ARMED FORCES RADIOBIOLOGY RESEARCH INSTITUTE
8901 WISCONSIN AVENUE
BETHESDA, MARYLAND 20889-5603

SUBJECT: Request for Additional Information RE: License Amendment, Separation
of Byproduct Material (TAC NO. ME4117)

By letter dated August 4, 2010, the NRC requested additional information concerning our license amendment request of June 16, 2010 (License R-84, Docket 50-170). Our responses to the six NRC questions are enclosed along with supplemental material as Attachments 1-4.

Figure 1. Sample vial design.

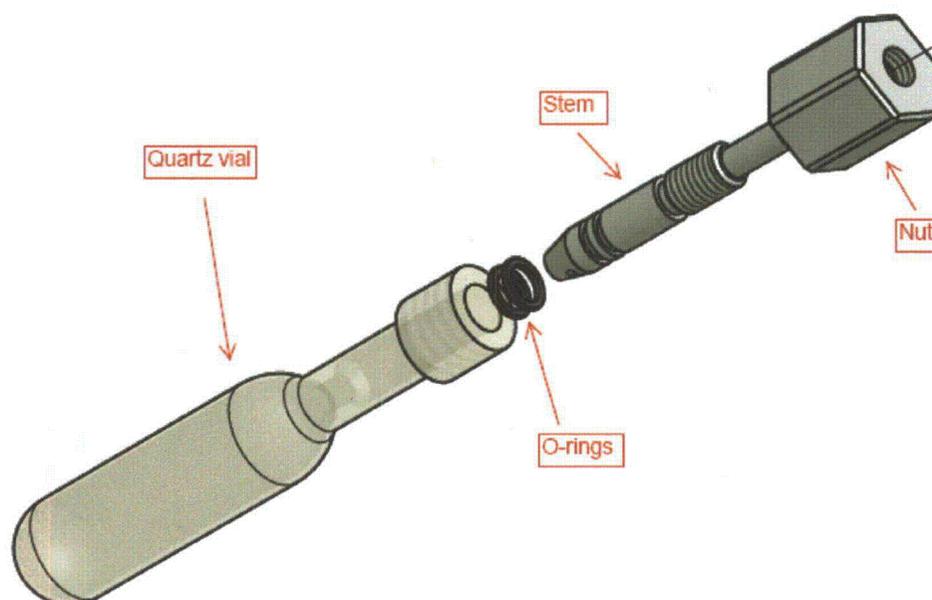
5. *The purpose of TS 3.6b. is to help ensure that the consequences of the accidental release of the fission product inventory of a fueled experiment is acceptable. While the consequences are acceptable, it is assumed that the failure of a fueled experiment will be a very rare occurrence. Likewise, the accidental release of the fission product inventory of a sample undergoing experiment or analysis as a separation experiment should also be a very rare occurrence. Your application states that laboratory scale experiments do not increase the frequency of an accidental release of radioactive material. Please discuss the features of separation experiment design that will help ensure that a failure that would release radioactive material from the experiment will be a rare occurrence.*

The materials selected for the design of the irradiation vials and their ability to withstand the desired level of radiation are described below:

The sample vial is equipped with gas sampling valve that seal sample during irradiation and allow drawing of the head space gases for analysis. Design of the valve is based on the standard

vacuum valve design. It uses a double o-ring seal on the stem and direct polymer to glass seal for the isolation of the gas sample.

The sample vial with valve consists of four parts: glass vial with thread, valve stem, nut, and set of o-rings. The principle design of the valve is depicted on the figure 1. The nut has two threads: left and right handed. When nut rotates, it pushes or pulls the stem. The stem slides on the set of two o-rings. The tip of the stem is coned to match saddle in the quartz vial body.

The commercial valve is manufactured using fluorinated polymers that provide good mechanical properties and great chemical resistivity but has poor radiation stability. Under radiation fields, fluorinated plastics lose mechanical integrity, so we had to replace materials used in the valve for more radiation resistant ones. In selection of the materials, we have used the guidelines from [1]. This book contains data for radiation stability of the polymers under x-ray irradiation. We have chosen medium density polyethylene for stem and for the nut manufacture and used Buna-N for the o-rings. Medium density polyethylene was chosen for the stem because of the mechanical properties; it is soft enough to make a reliable seal, but rigid enough to be machined. Buna-N o-rings were chosen because of the better radiation stability compared to

Viton. We have irradiated all materials at the Van de Graaff electron accelerator, and all materials have shown no degradation of the mechanical properties for radiation doses up to 200 MGy.

One can argue that inside of the reactor, the valve will be in the high intensity neutron field; however, there is discussion in the literature on applicability of the results obtained for one type of radiation for different forms of radiation on the stability of the polymers. Unfortunately, in the open literature, there are only a few studies of the mechanical stability of the polymers in neutron field. There are many studies that address changes in the physical properties of the polymers under different forms of radiation, but we are only interested in properties that affect mechanical stability. We were able to find one manuscript that compares the effects of different form of radiation on mechanical stability of the polymers [2]. According to this study, there is no significant degradation of the mechanical properties for polyethylene under proton, gamma, and neutron irradiation for the doses up to 20 Mrad. This literature review gives us confidence that the materials used in the sample vial with this valve will withstand irradiation in the reactor and ensure integrity of the valve. Each sample container will be used only once and then discarded.
